PRODUCT CHANGE NOTICE

PCN Number: 20-1026A

Series: Standard target pin packaged on tape and reel

Part Numbers Affected: 7937-0-58-15-00-00-03-0

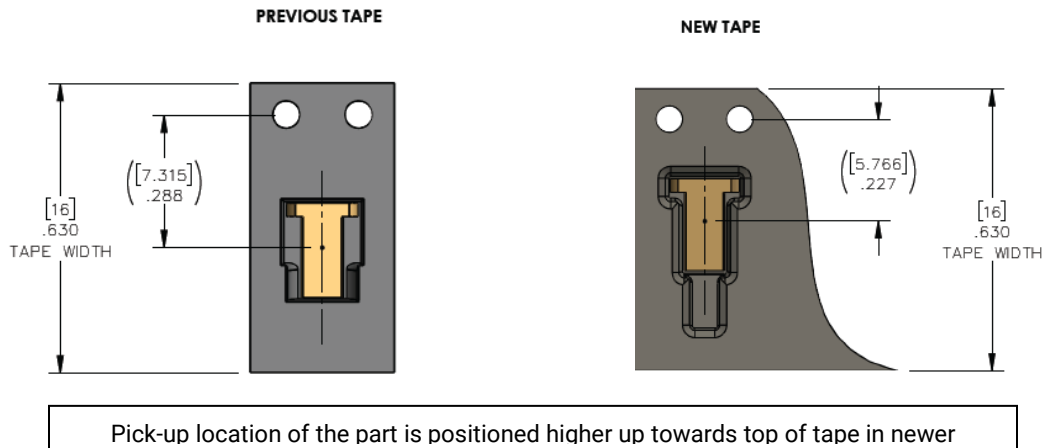
Type of Change: Packaging change only, no physical change to part. The parts per reel will change from 2,400 to 2,800 parts per reel.

Description of Change: Tape pocket design will change. This will change the pick-up location of the part, relative to the sprocket holes, when using a pick & place machine for automated assembly. There is no change to the carrier tape width or pocket pitch.

Reason for the Change: To better contain the part in the tape pocket.
